H.B. Van Duzer Forest Corridor – Steel Bridge Road

Revised Environmental Assessment

**Oregon Department of Transportation
Federal Highway Administration**

July 2004

FIGURE 3A
Overview of the Preferred Alternative (West)

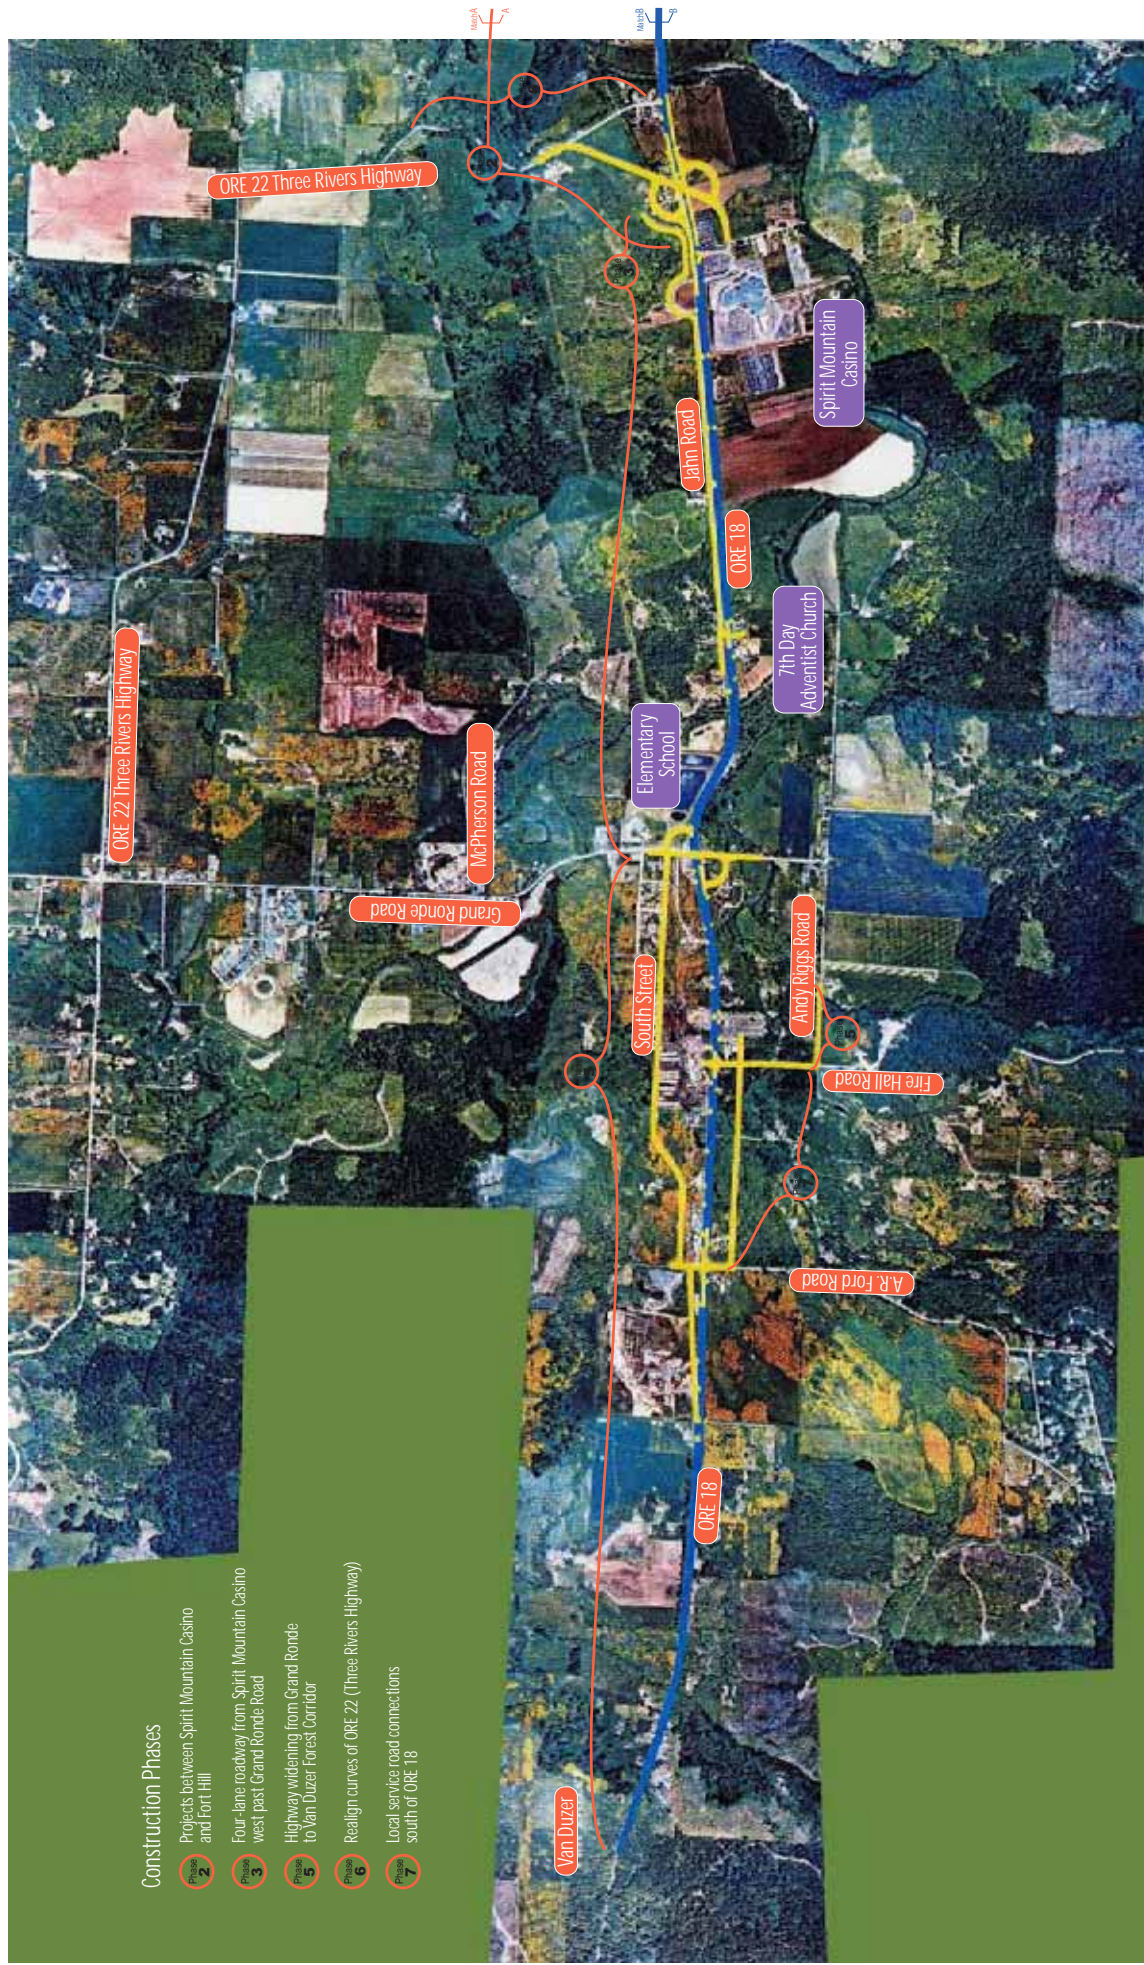
NOTE: This figure replaces 3-1 in the EA.

FIGURE 3B
Overview of the Preferred Alternative (East)
 H.B. VAN DUZER FOREST CORRIDOR — STEEL BRIDGE ROAD

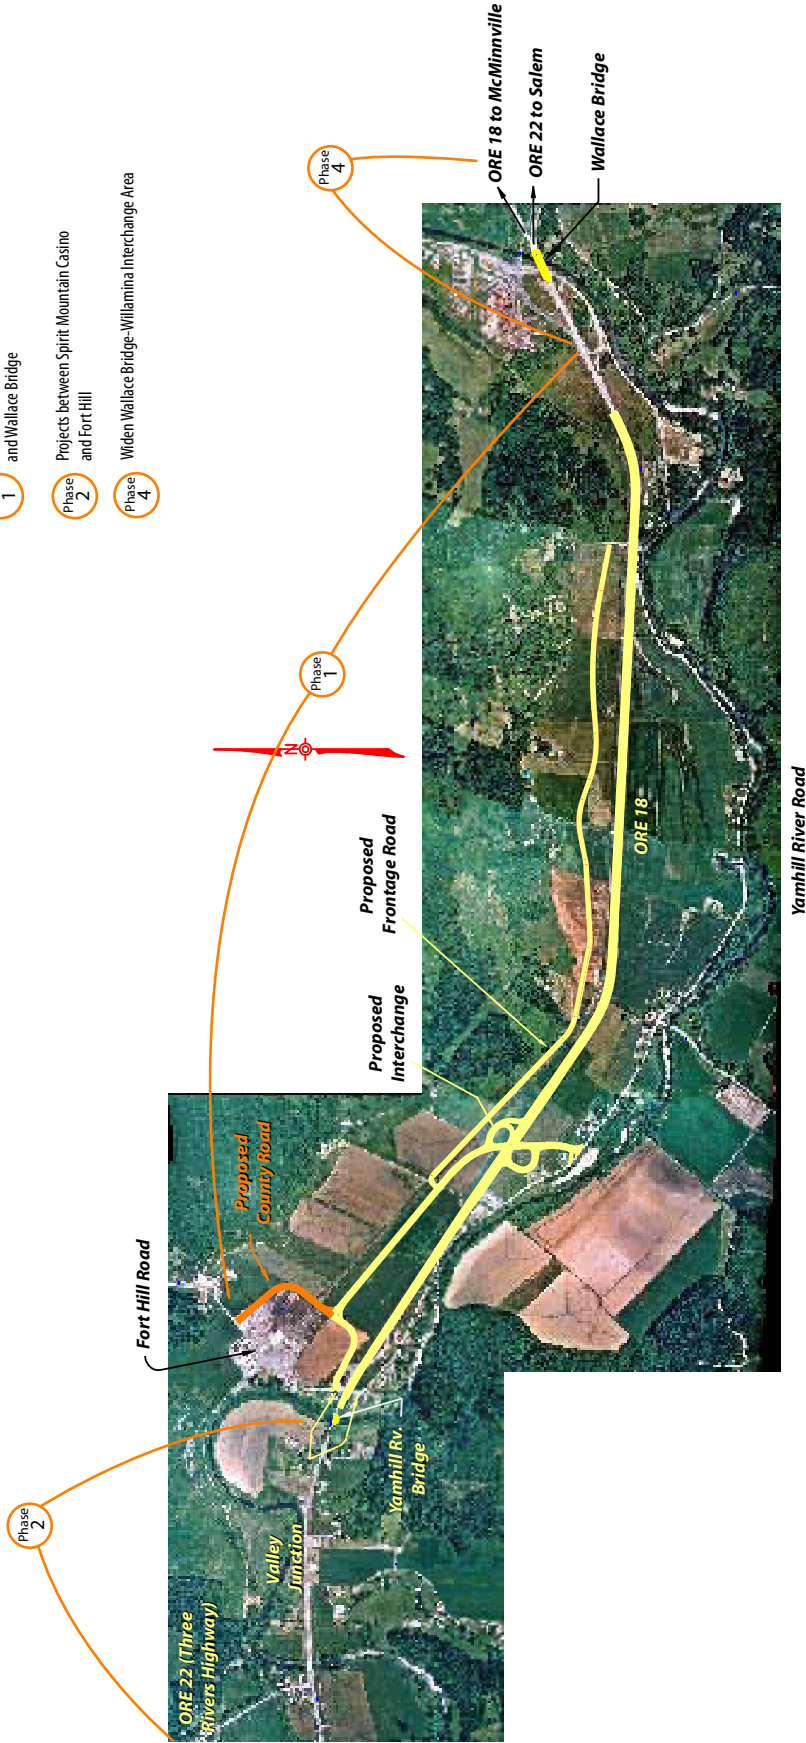
NOTE: This figure replaces 3-2 in the EA.

Figure 4A
Current Polk County Zoning (West)
H.B. Van Duzer Forest Corridor — Steel Bridge Road

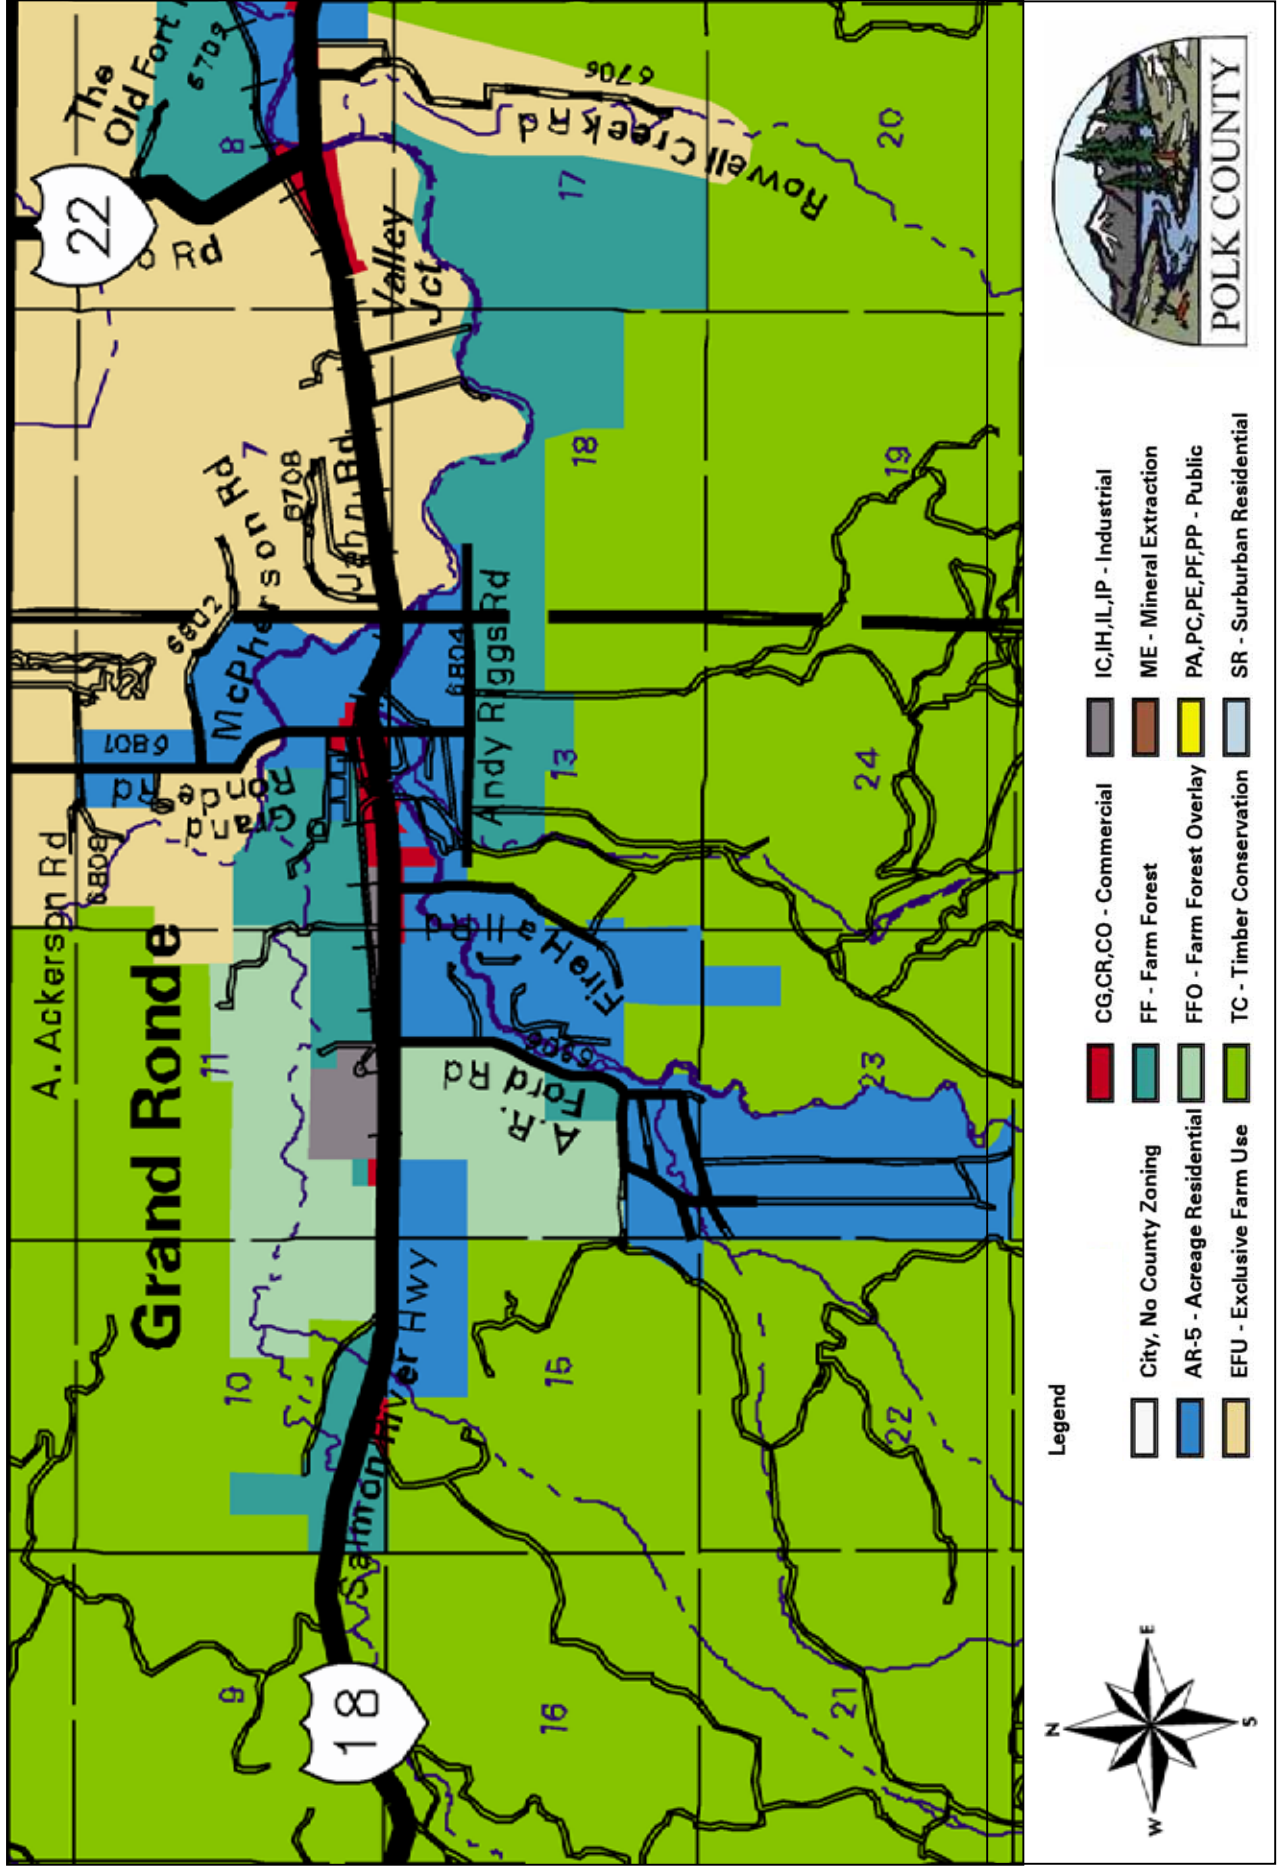
NOTE: This figure replaces 22-1 in the EA.

NOTE: This figure replaces 22-2 in the EA.

Figure 5
Grand Ronde Current Zoning
H.B. Van Duzer Forest Corridor — Steel Bridge Road

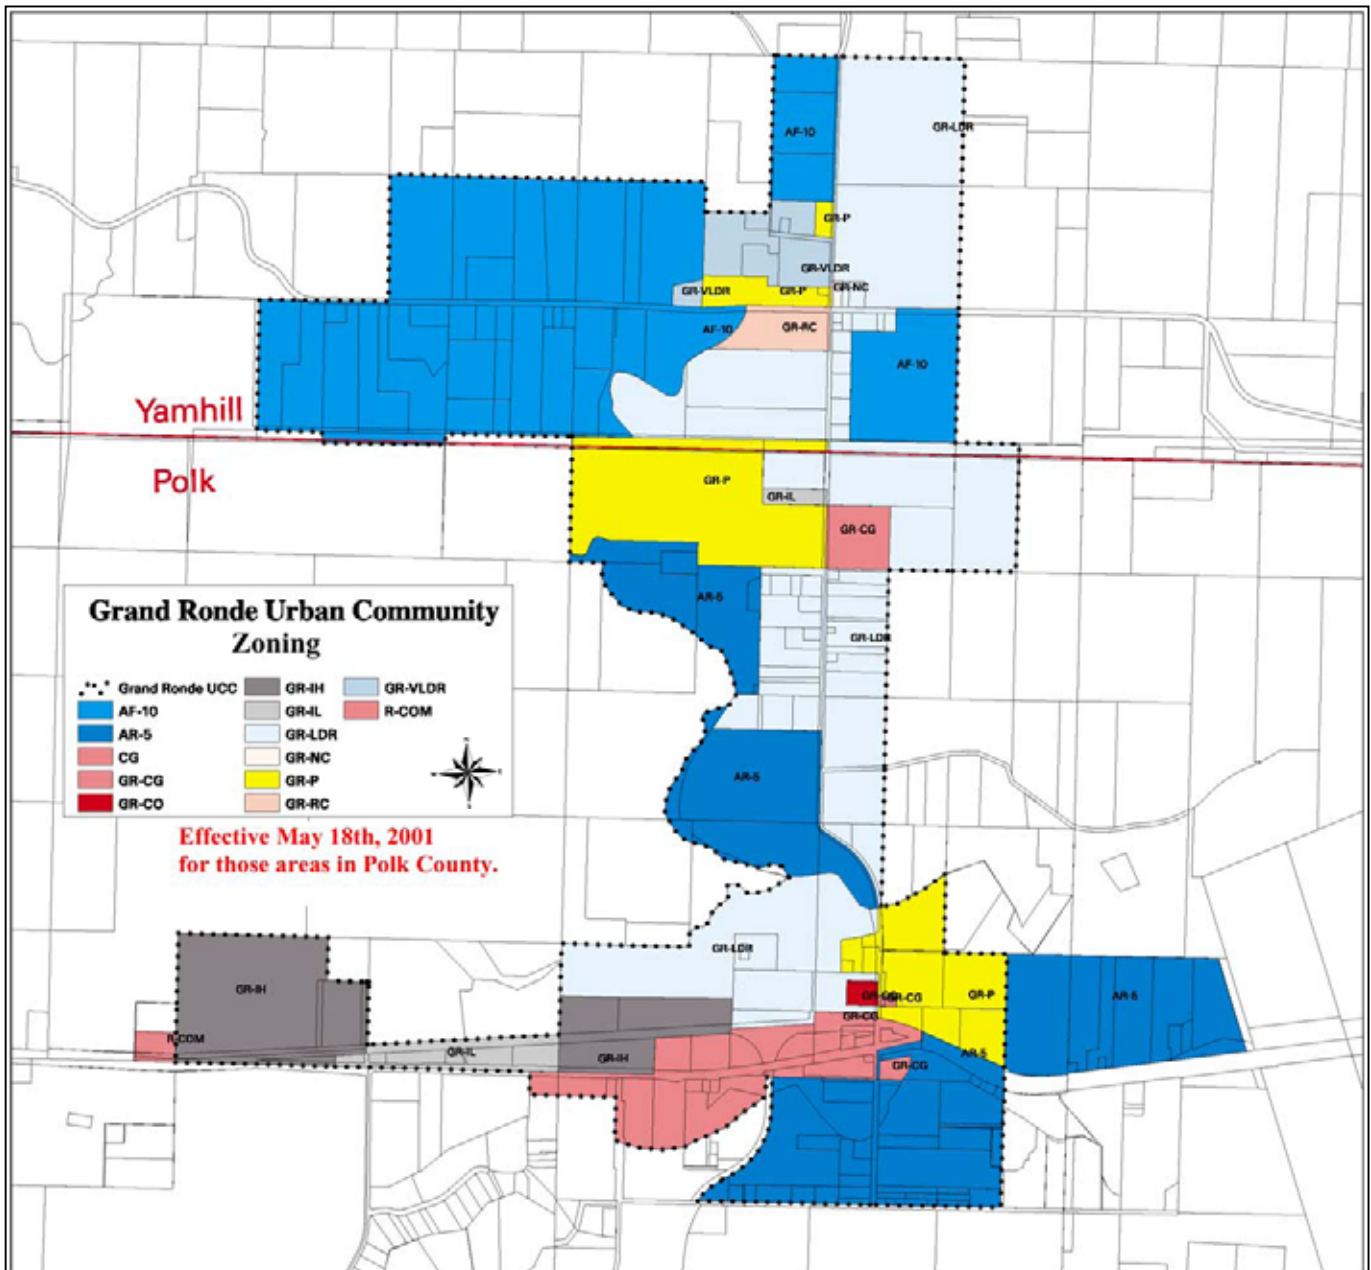
NOTE: This figure replaces 23-1 in the EA.

Figure 6
Fort Hill/Valley Junction Current Zoning
H.B. Van Duzer Forest Corridor — Steel Bridge Road

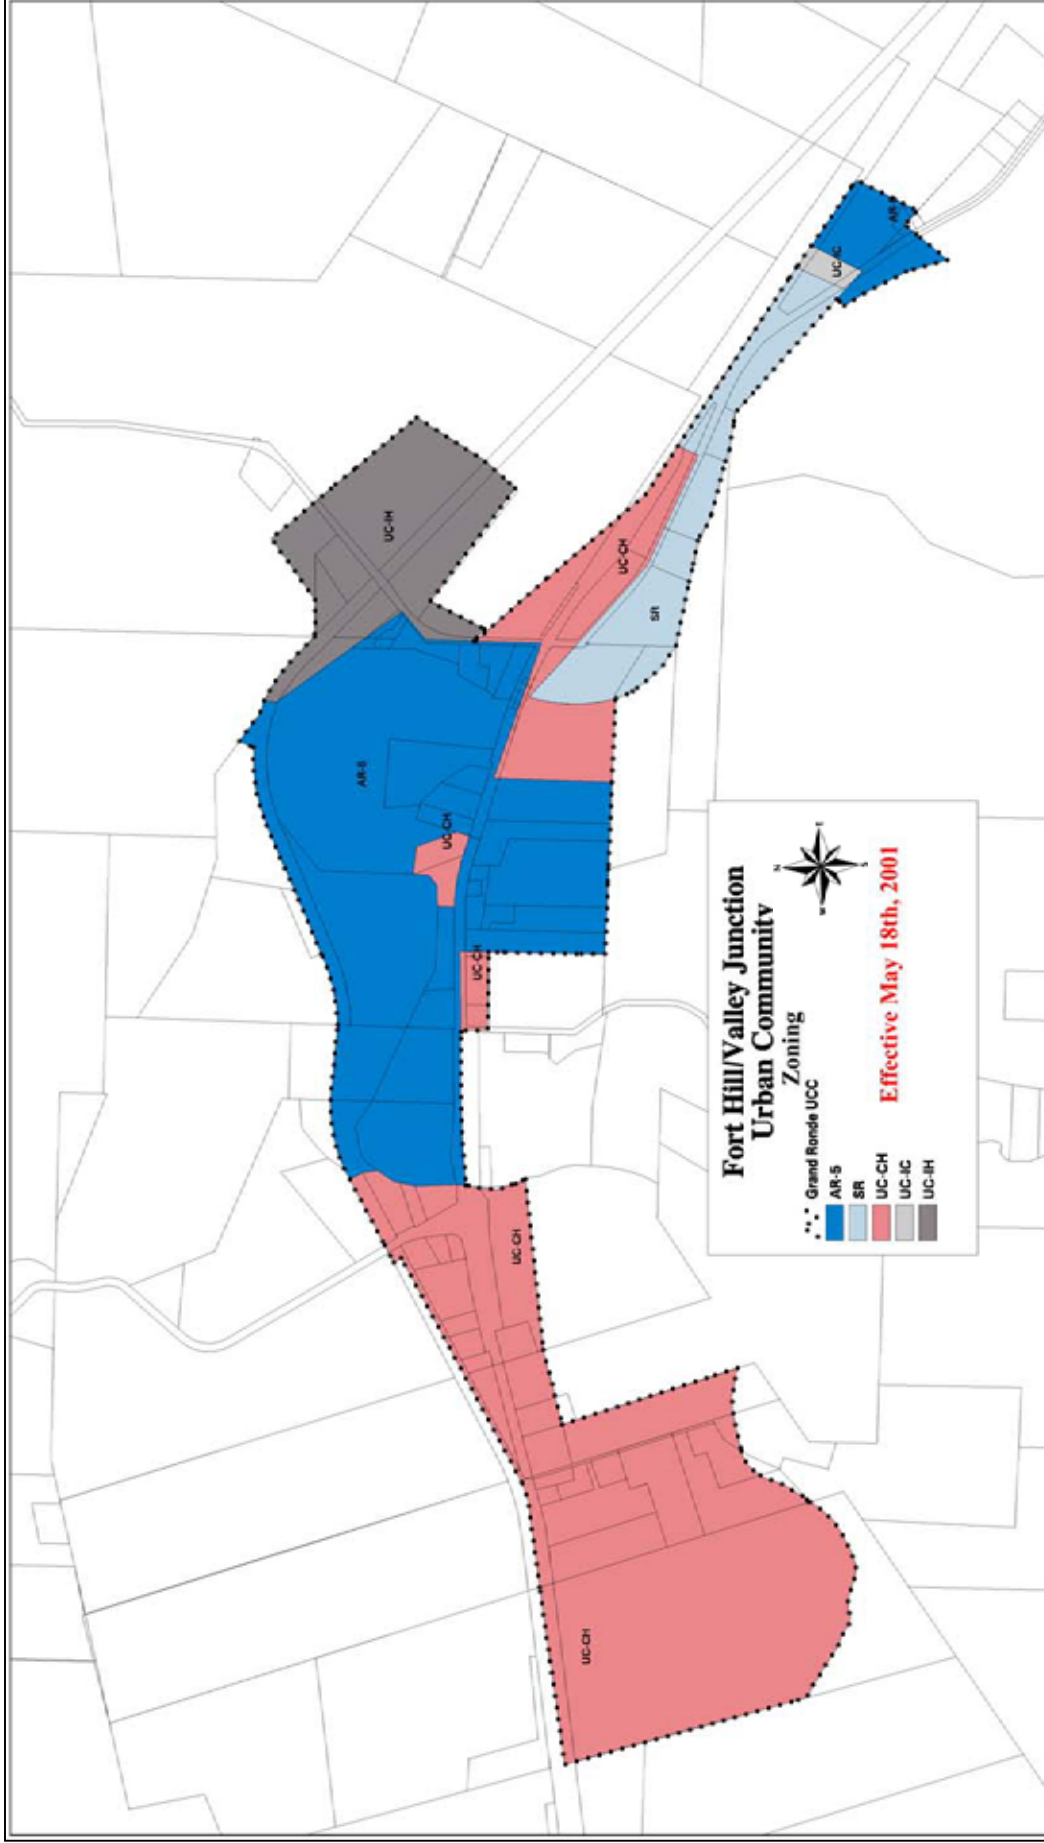
NOTE: This figure replaces 23-2 in the EA.
